Masterplan Envelope Revisions 2.2

Revisions in permissable 3D massing as shown in the Approved Concept Masterplan MOD09 to the proposed Concept Masterplan MOD10, as a result of change in use

## **MOD9 - Approved Concept Masterplan Envelope**

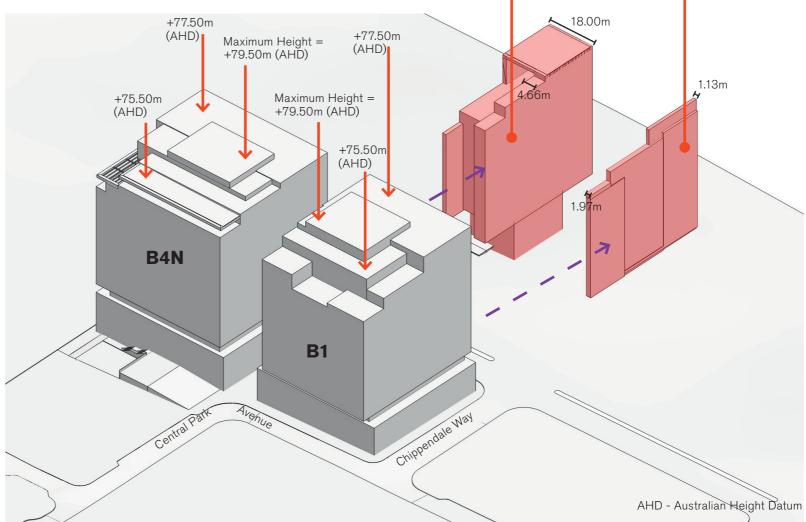
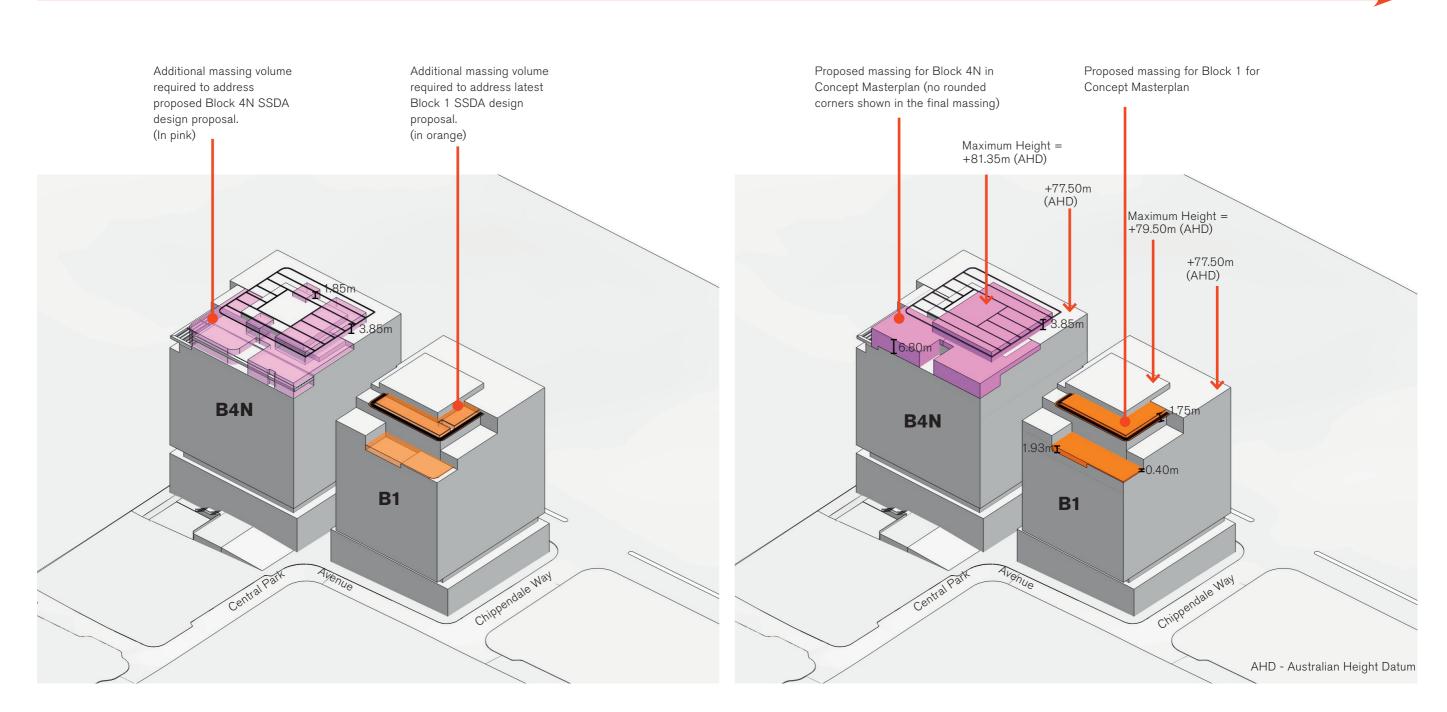
Bridge link between Block 4N - Block 1 to be deleted due to change in use of Block 1 to residential.

Revised volume of Block 1 amended to allow for 18m building separation as required by SEPP 65 between Block 1 and Block 4N when above 25m between habitable room to habitable room.

Slice of Block 1 Envelope to east to be deleted to allow for 24m building separation between Block 1 and Block 2 as required by SEPP 65 due to change in use to residential for Block 1, above 25m between habitable room to habitable room.

03 - Massing to be added to address latest SSD Application for Block 1 and Block 4N
